Eastern Creek Recycling Ecology Park Mod 10

Landfill gas capture and treatment project
State Significant Development Modification Assessment
(06_0139-Mod-10)

March 2022

Figure 3 | Proposed modification (also showing (labelled in green) the existing LFG infrastructure not included in this modification)

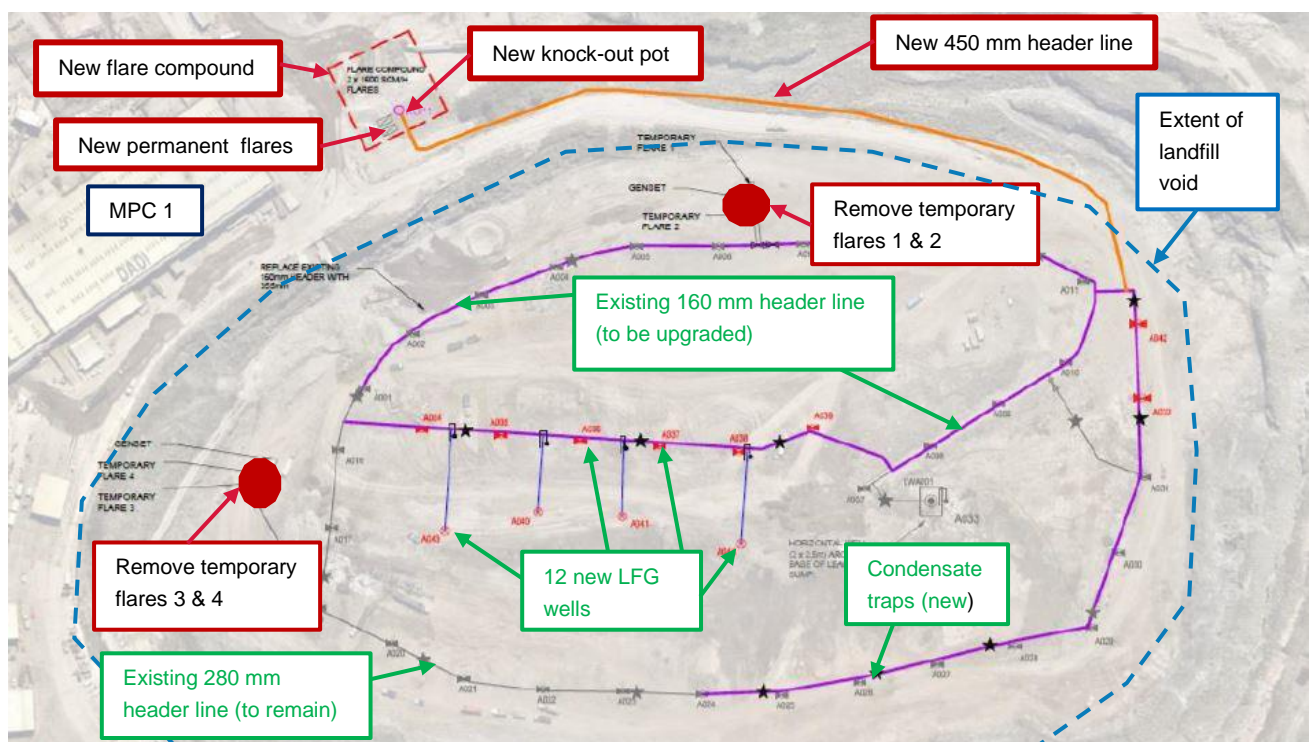
The Applicant has lodged a modification application under section 4.55(1A) of the EP&A Act to install and operate a permanent LFG flare system to replace the existing four temporary LFG flares installed in the landfill void during 2021. The modification is described in full in the Statement of Environmental Effects (SEE) included in **Appendix A** and is illustrated on **Figure 3**. The modification seeks to:

- install and operate two permanent enclosed LFG flares, with a combined treatment capacity of 3,000 Sm³.hr at a location approximately 50 m northeast of MPC 1
- install supporting infrastructure for the flares:
 - engineered concrete hardstand base (area 19 m x 34 m) for flares
 - a stainless-steel condensate knockout pot
 - 1.8 m high palisade security fence (area 45 m x 45 m) around the flare compound
 - a new 450 mm main header line connecting the existing LFG collection system in the landfill void to the new flares
- decommission the four temporary LFG flares located in the landfill void

In addition, works are required to upgrade the existing LFG collection system in the landfill void. The Applicant considers that, as these works are upgrades to the existing system, they do not require further approval and **do not form part of the modification** (see **Figure 3**). These works include:

- installation of 12 new gas collection wells (additional to the 31 existing wells)
- replacement of a portion of the existing 160mm header line with a new 355mm header line
- extension of the LFG network through the installation of additional 355mm header line
- construction of in-line barometric condensate traps to remove any condensate build up
- remedial works required to compact the clay liner back to its previous state.

Figure 5 | Receptor zones surrounding the site

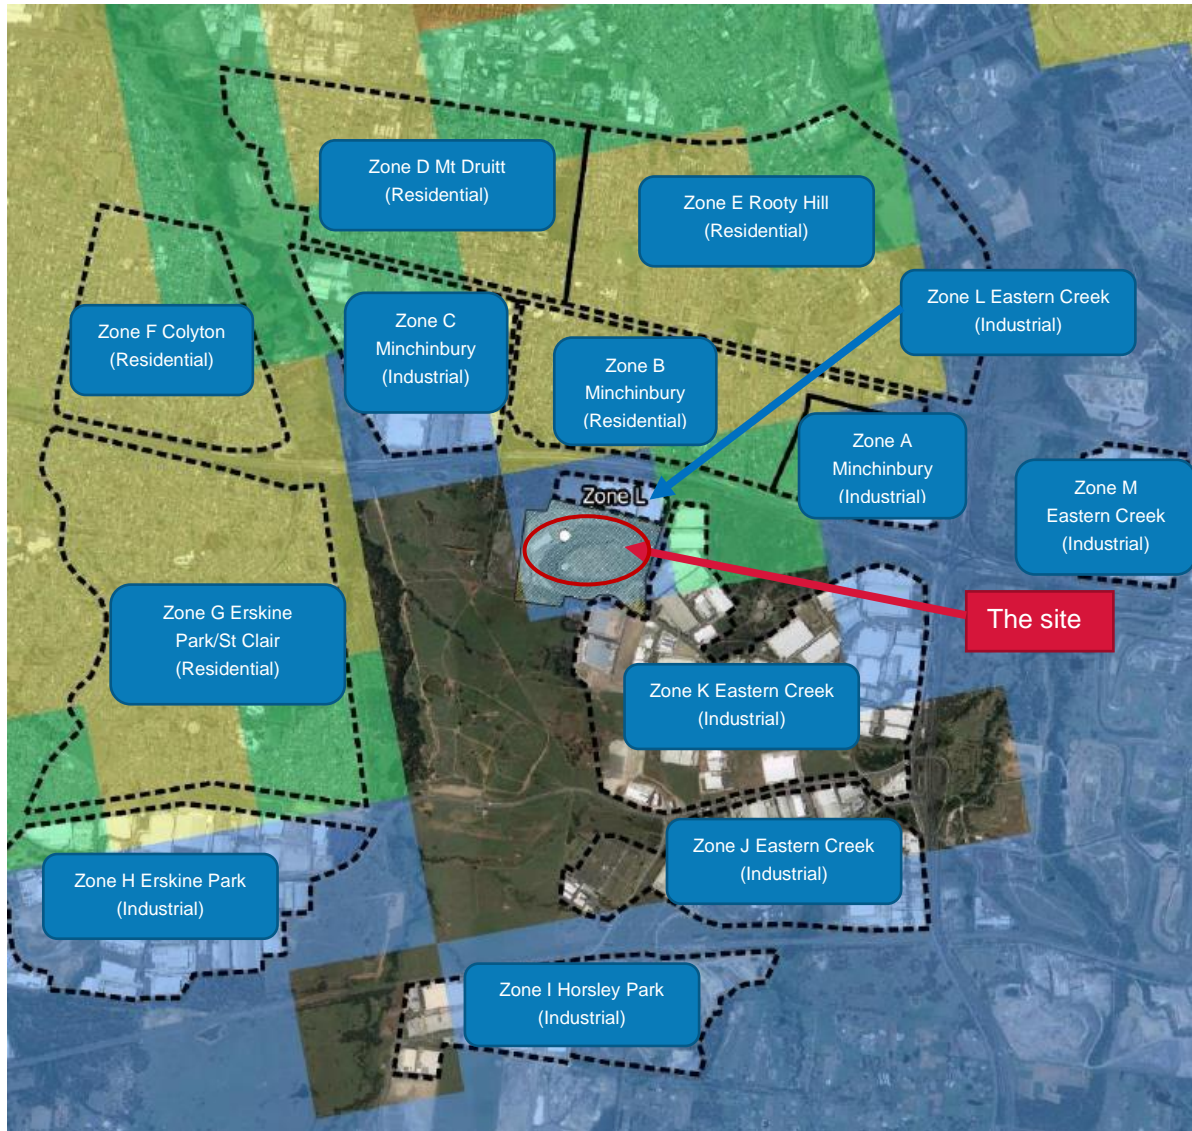
The AQIA divided neighbourhoods in the site's vicinity into 13 'receptor zones', which were classified by their population density and distance from the flares. Distances ranged from 229 m to 3,366 m away (see **Figure 5**). In total, these zones represent 4,900 individual locations, including sensitive receivers in the residential areas of Minchinbury, Mt Druitt, Rooty Hill, Colyton, Erskine Park and St Clair.

The AQIA identified the relevant NSW EPA air quality criteria for the key pollutants of concern, being Sulphur Dioxide (SO₂), Nitrogen Dioxide (NO₂), Carbon Monoxide (CO), Hydrogen Sulphide (H₂S), Particulate Matter (PM₁₀ and PM_{2.5}) and Total Suspended Particulates (TSP). Dispersion modelling predicted operational air quality impacts at the receptor zones using the conservative assumption of 70% gas capture (rather than the expected 85%). Modelling results showed the relevant maximum and annual average concentrations for SO₂, NO₂, CO and H₂S would be below the relevant criteria at all residential and industrial receivers.

In terms of the maximum 24-hour average for PM₁₀ and PM_{2.5}, exceedances of the air quality criteria (50 µg/m³ and 25 µg/m³ respectively) were observed due to elevated background levels detected at

three air quality monitoring stations near the site. For PM₁₀, the addition of the predicted PM₁₀ concentrations would not result in any additional exceedances even under a conservative scenario. For PM_{2.5}, under a worst-case scenario a nominal cumulative exceedance of the relevant criterion was predicted at receptor zones A, B, K, L, however there would be no additional exceedances of criteria due to the operation of the flares.

The EPA did not have any specific concerns regarding the flare technology, however required that design, installation, and operation of the flares comply with certain design criteria, the POEO Clean Air Regulation and the EPA's Landfill Guidelines. As limited information was provided to support the assumption of 85% flare efficiency, the EPA also required evaluation of the flares' performance and

effectiveness following commissioning. In addition, the EPA noted some uncertainties in the assumptions in the AQIA around H₂S surface emissions from the landfill, as well as H₂S and SO₂ flare emission rates. However, as the modification has been identified as a priority to minimise air quality impacts on nearby receptors, the EPA recommended conditions of consent to address the uncertainties.

The Department has reviewed the AQIA and GHGA, noting the low potential for construction impacts and the earlier public concerns about odour emissions from the site. The Department notes the dispersion modelling demonstrates concentration levels at surrounding sensitive receivers would meet the relevant criteria for the key pollutants of concern and there would be no additional exceedances as a result of the modification. The Department also notes the positive impacts of the flares reflected in the large reduction in GHG emissions.

The existing consent includes a requirement for an AQ Plan which includes a program for monitoring subsurface gas, surface gas emission, and gas accumulation. However, in line with the EPA’s concerns regarding uncertainties in the modelling, the Department has recommended verification and evaluation of actual fugitive LFG emissions, LFG collection efficiency, and actual H₂S emission rates following commissioning of the flares.
